BOULDER COUNTY BOARD OF ADJUSTMENT

Docket VAR-23-0005: Schaefer Variance

Request: Variance request to reduce the side-yard setback for the south property line from 25 feet (required) to 12.5 feet (proposed) for the construction of a retaining wall and entry stairs that will replace an existing retaining wall and entry stairs that currently encroach 13.4 feet into the side-yard setback on an approximately 5.61-acre parcel.

Figure 1: Site plans depicting the existing retaining wall and entry stairs that currently encroach into the side-yard setback (circled in red) that are proposed to be demoed and replaced.

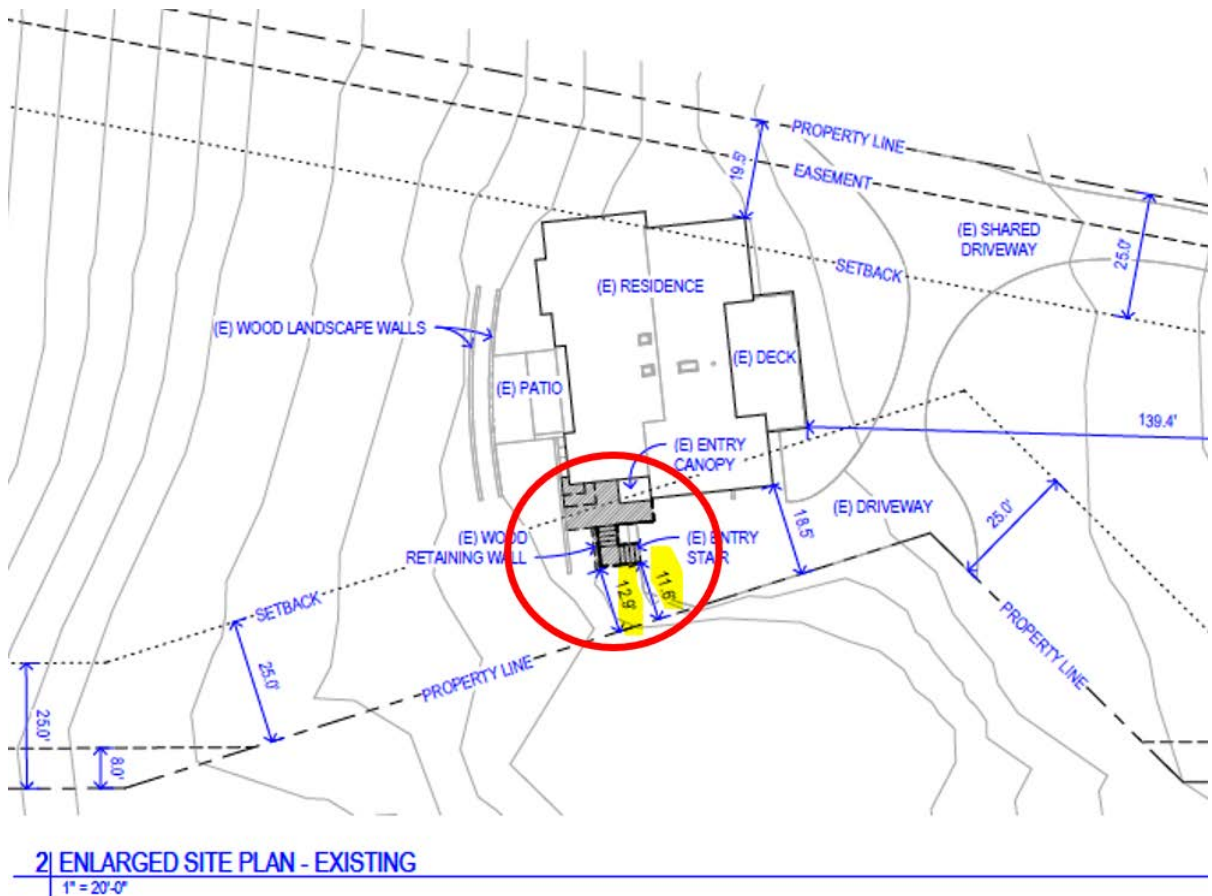
The Forestry zoning district requires a 25-foot setback from the side lot line per Article 18-175.C of the Code. A Variance approving a 20-foot setback from the south lot line was granted in 1975 for the existing residence. The building permit (BP-75-20227) for the existing residence shows that it meets these approved setbacks; however, current building permit plans show that the residence, retaining wall, and entry stairs all encroach into the setback as illustrated in Figure 1 below and do not actually comply with the reduced setback granted in 1975.

The applicant requests a 12.5-foot variance from the required 25-foot side-yard setback to allow for the replacement of the existing retaining wall and entry stairs, which the applicant states currently pose a health concern and potential future safety concerns. Figure 2 below illustrates the proposed improvements to these existing structures.

Figure 2: Site Plan showing proposed improvements of the retaining wall and entry stairs (circled in red). The plans indicate the proposed replacement of the retaining wall and entry stairs will reduce the encroachment of both structures from what currently exists.

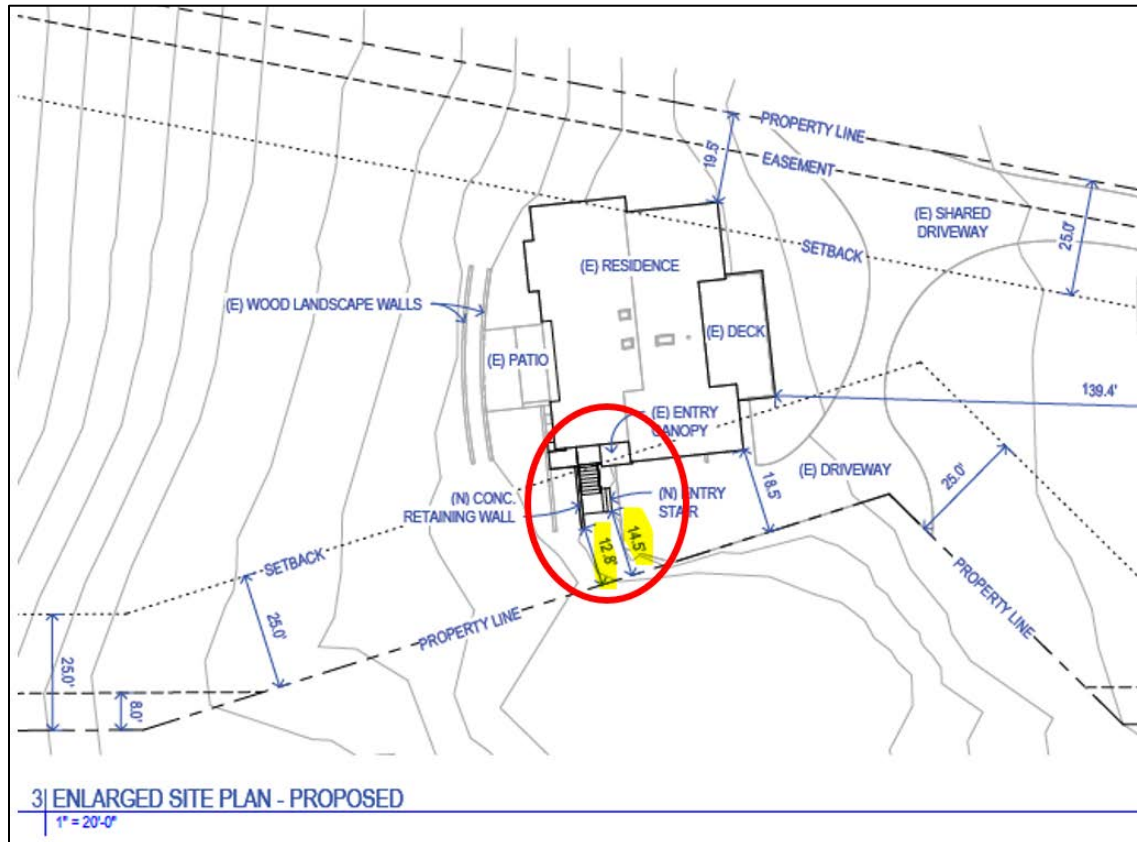
The applicant notes that rodents take shelter under the enclosed stairs and the retaining wall provides structural support to the abutting hill side. The proposed replacement entry stairs would be open as to not act as a shelter for animals and the 49-year-old retaining wall would be reconstructed for increased stability.

Figure 3: Site plan depicting the narrowness and existing topography on the subject parcel, with the existing residence located on the eastern portion.

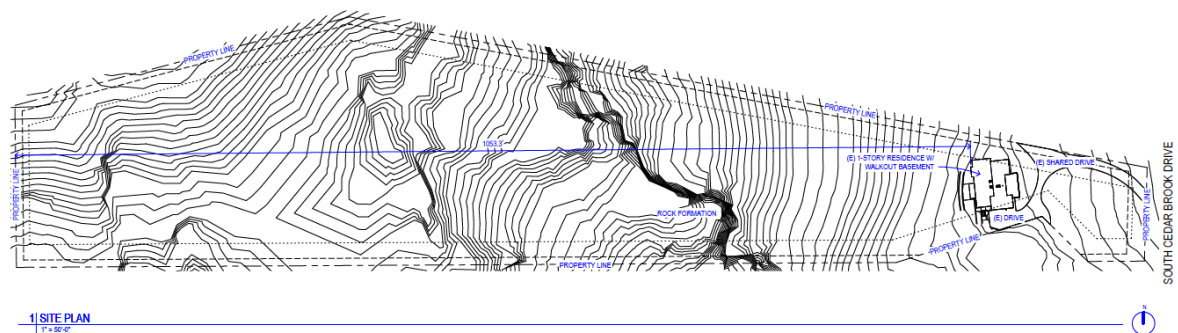
The subject parcel is long (approx. 1,246 feet) and starts off narrow (approx. 100 feet), and widens gradually towards the center of the lot. It is approximately 5.61 acres in size. The topography is moderately sloped on the narrower eastern portion where the residence is located on the hillside, but becomes very steep and rocky. This topography creates construction challenges as you move west along the parcel (see Figure 3 below). Given the subject parcel's steep slopes and narrow configuration in the buildable area staff finds that there are extraordinary and exceptional physical characteristics.
